Access Compliance Report

Public Rights-of-Way

Intersection ID: 15632	Main Street: EXECUTIVE_CENTER_DR	Cross Street: FARM_POND_LN	Location: NW
ADA ID: 2618D830A453	Ramp Type: PerpDiag	Initial Pass/Fail: Fail	Overall Compliance: No
Severity Score: 21.25			
Codes/Mitigation Info/Possible Solution		Field Measurements/Component Compliance

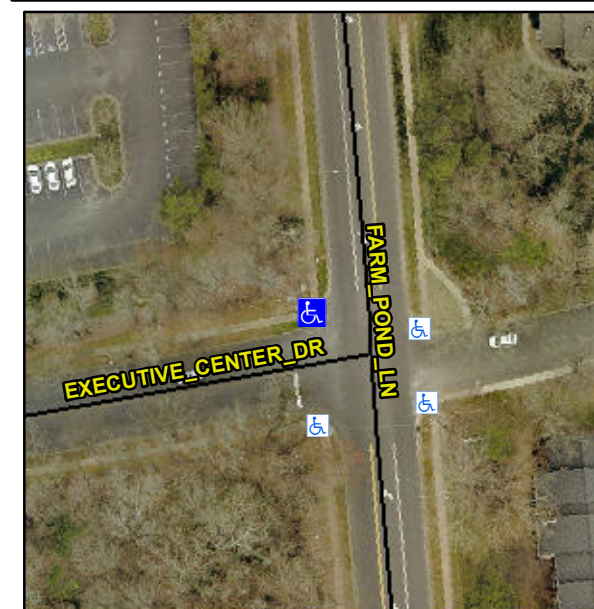
Not Found, R304.5.1, R304.2.2

Compliance	Description	Data	Compliance	Description	Data
N/A	Ramp Length (in)	30.0	No	Ramp Slope (%)	11.1
No	Ramp Width (in)	36.0	Yes	Ramp XSlope (%)	0.1
N/A	Flare Type LT	N/A	N/A	Flare Type RT	N/A
N/A	Flare Slope LT (%)	N/A	N/A	Flare Slope RT (%)	N/A
N/A	Flare Traversable LT?	N/A	N/A	Flare Traversable RT?	N/A
N/A	Landing Length (in)	N/A	N/A	DWS Provided?	N/A
N/A	Landing Width (in)	N/A	N/A	DWS Contrast?	N/A
N/A	Landing Slope (%)	N/A	N/A	DWS Length (in)	N/A
N/A	Landing X Slope (%)	N/A	N/A	DWS Full Width?	N/A
N/A	Landing Curb? (Y/N)	N/A	N/A	DWS Offset (in)	N/A
N/A	Shared Landing?	N/A			
N/A	Gutter Ponding?	N/A	N/A	Gutter Slope (%)	N/A
N/A	Gutter Lip Ht (in)	N/A	N/A	Gutter X Slope (%)	N/A
N/A	Painted X Walk1?	No	N/A	Painted X Walk2?	No
	X Walk 1 Direction	To S		X Walk 2 Direction	To E
N/A	X Walk 1 Width (in)	N/A	N/A	X Walk 2 Width (in)	N/A
	X Walk 1 Slope (%)	4.2		X Walk 2 Slope (%)	5.5
	X Walk 1 X Slope (%)	4.5		X Walk 2 X Slope (%)	0.2

Remove & Replace Curb Ramp With Two New Directional Ramps or Equivalent.
